In reply please quote: 22/25794

1 October 2024

SSD-50972718 – PROPOSED WALLGROVE ROAD BUSINESS HUB WITHIN WESTERN SYDNEY PARKLANDS AT 97-151 WALLGROVE ROAD, HORSLEY PARK (Lot 25 DP 2954 and Lot 24 DP 1152887)

Figure 1: Proposed access arrangement.

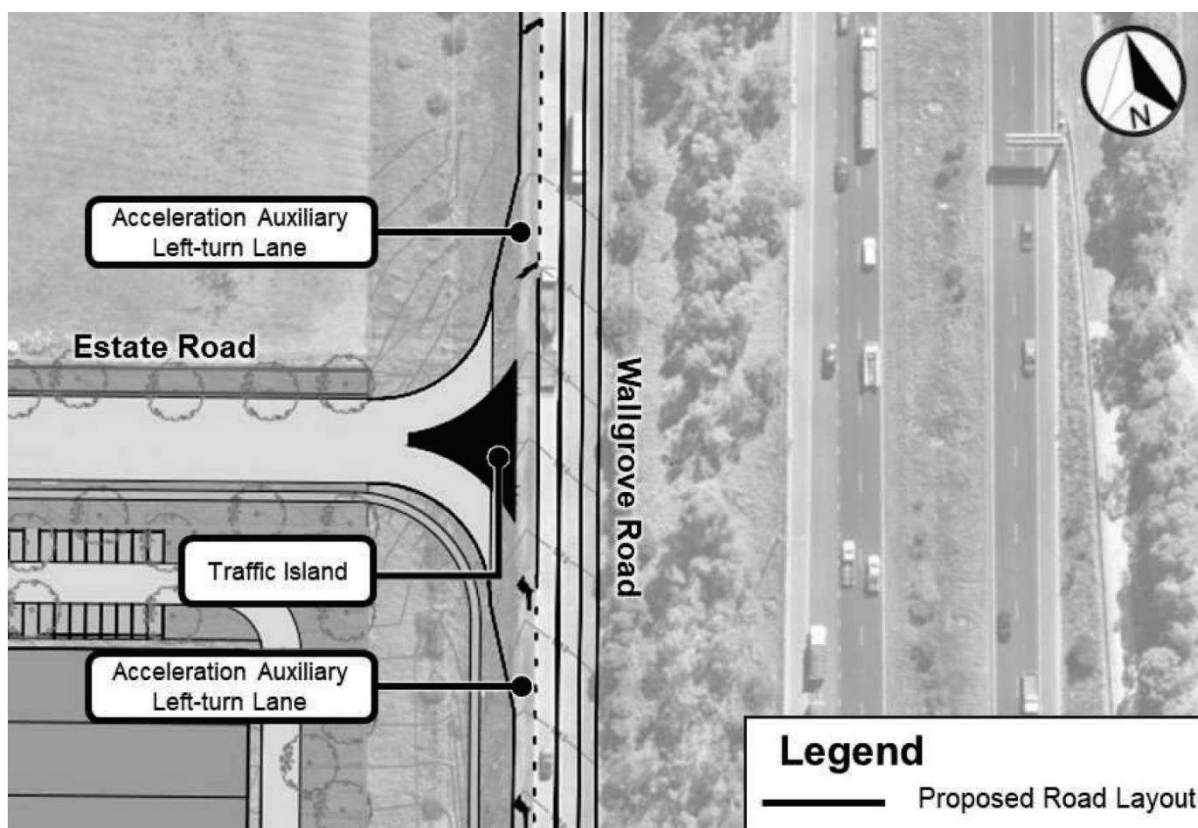
Council considers there are significant issues associated with construction of a compliant acceleration lane. As the applicant is aware and as mentioned in Section 3.4 of the EIS, TfNSW has approved a new access arrangement for the Wallgrove Road/Kosovich Place intersection. Provision of the acceleration lane associated with SSD 50972718 would conflict with northbound left turn movements at the Kosovich Place intersection and raise safety issues. In addition, 910m is noted to be rather extensive for an acceleration lane. Thus, it is recommended that any acceleration lane be subject to further investigation and discussion with TfNSW.

Furthermore, as part of the proposed ‘left-in/left-out’ access arrangement a traffic island is proposed to ensure access/egress movements were restricted to left-turning movements only. Design of this traffic island was based on swept path analysis of left-turning access/egress movements for 19m semi-trailers. Details of this swept path analysis are also provided as part of the concept plan in Appendix B of the EIS.
